Certified Action of the City of Raleigh Planning Commission

Case File / Name: S-37-10 / Edwards Townhomes Lot 2

Nature of Case: Infill subdivision of .300 acres into 3 townhome lots zoned Residential-10.

S-37-10 Edwards Townhomes lot 2 - subdivision plan

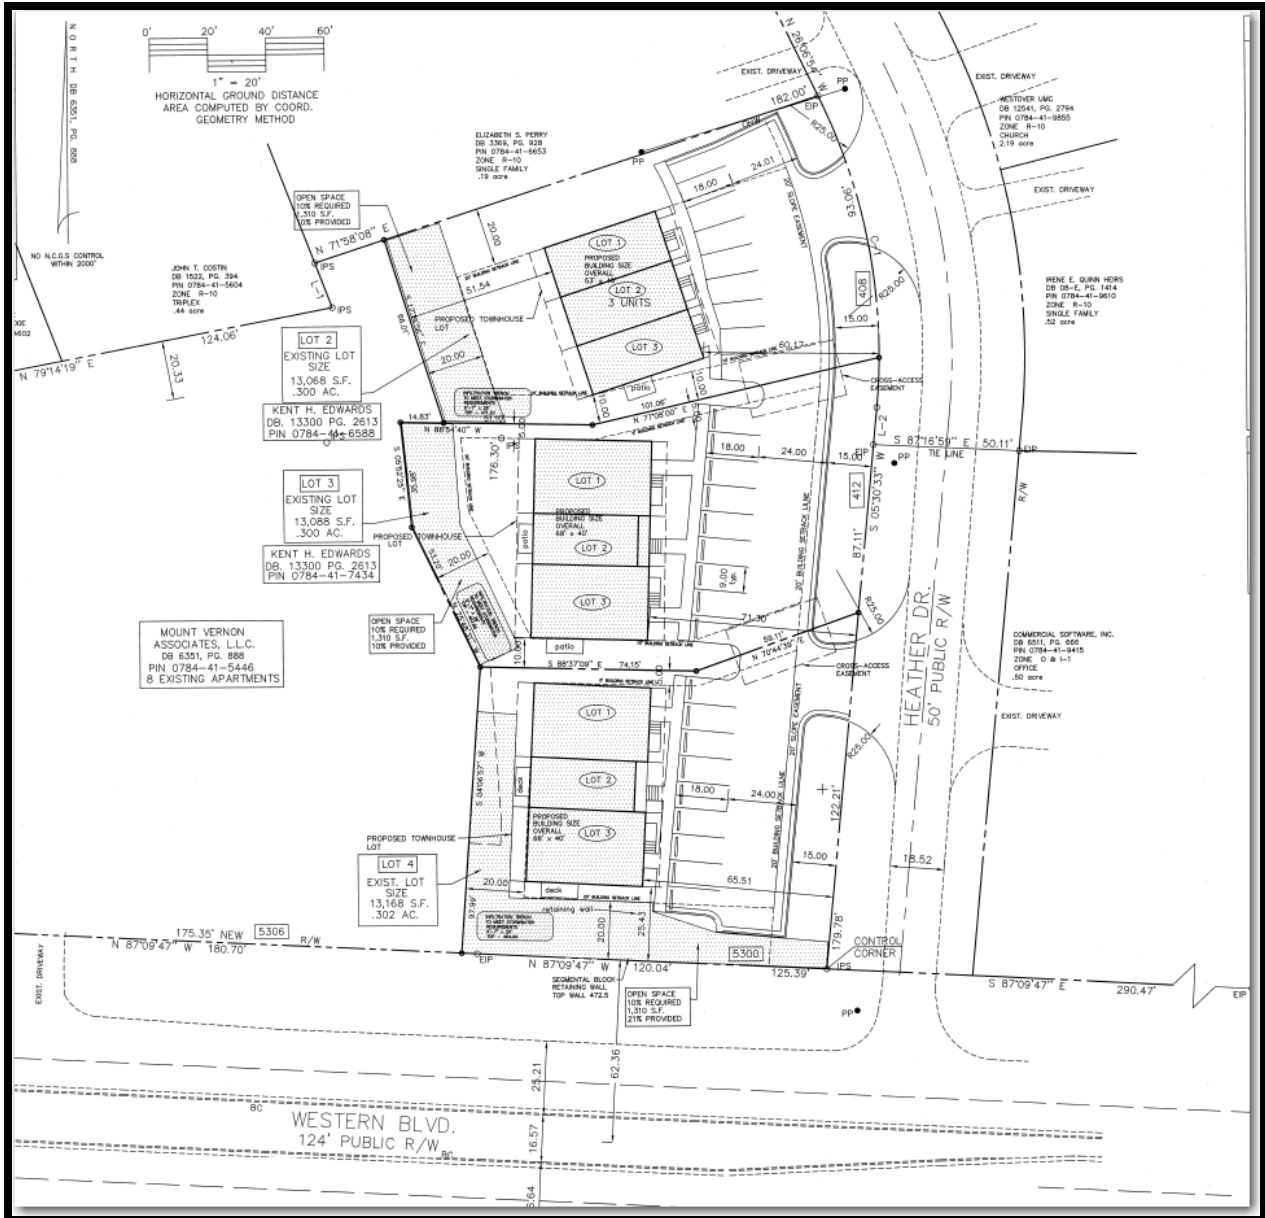
<u>Comment</u>	<u>Response</u>
1. The committee recommends that building materials to be used on the front facades be continued on all other sides [commensurate with Code Sec. 10-2132.2(d)(6)]. While the owner has not prepared the detailed elevation of all sides of the proposed building, be assured that all sides of the proposed buildings will be of similar design and materials as the front elevation.

2. If parking lot lighting is installed, scale pole height to pedestrian use and install low-glare, cutoff fixtures [commensurate with Code Sec. 10-2132.2(d)(3)]. The owner is not sure at this time if any pole lights will be placed in the parking area for the units. If pole lights are used, they will be low carriage style lights at 12'-16' ht..

3. Install site sidewalks at the time of site development rather than paying a fee in lieu [commensurate with Code Sec. 10-2132.2(d)(1) & (2)]. The City Transportation staff has indicated they would rather have a fee-in-lieu of construction of curb & gutter and sidewalks for Heather Drive. The owner is agreeable with the staff recommendation.
